**Chemung County Stormwater
Construction Inspection
Erosion and Sediment Control**

Project Name Barrington West Lot 54	Date 6-28-2022
Location Royal Crest Horseheads, NY	Permit # NYR11F212
Weather Conditions sunny warm	Entry Time: 10:26 am
On-Site Representative Present: Roz Steadman	Exit Time: 10:50 am

PROJECT: Barrington West Lot 54
Town of Horseheads
Municipal Inspection
June 28, 2022

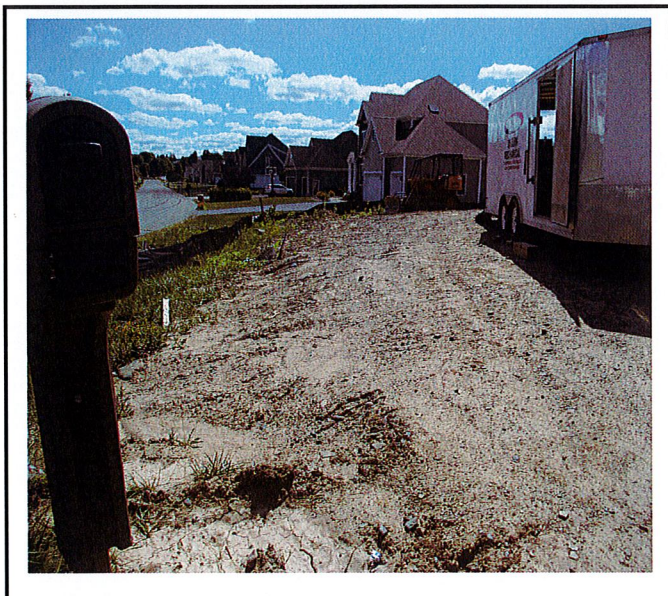
Erosion occurring at rear of property.

Silt fence not toed in where electric line needs to be buried.

Bare compacted soil is eroding due to lack of stabilization.
